THE ROVER COMPANY LIMITED

LAND-ROVER SERVICE NEWS LETTER
No. 16

November 1961

Fig. 1. Hot spot adjustment.

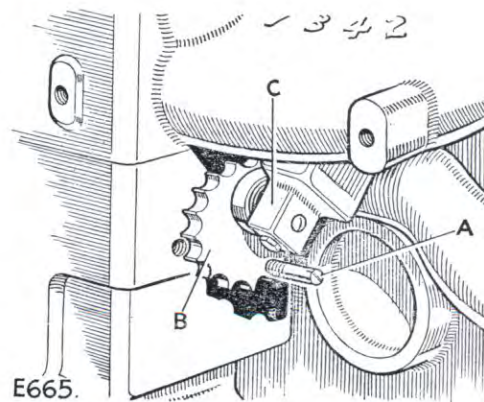
- REMARKS: Some complaints have been received of difficulty in starting the Land-Rover 2 $\frac{1}{4}$ litre Petrol engine when it is hot. On investigation it was found that in most cases this was due to the incorrect setting of the thermostatically controlled hot spot on the exhaust manifold. If the bi-metal spring is adjusted so tightly that it prevents the flap from closing completely when the engine is hot, the extra heat being fed to the inlet manifold, causes percolation of the fuel in the carburetter, so causing flooding. This causes difficult hot starting as well as allowing the fuel that drips from the pump injector to lie on the throttle blade and eventually leak from the throttle spindle. The thermostatically controlled hot spot should be adjusted as follows:—

1. Remove the retaining set screw A and turn the serrated adjustment plate B in an anti-clockwise direction until the balance weight C is just supported.

2. Replace the retaining set screw, selecting the appropriate serration, then tighten.
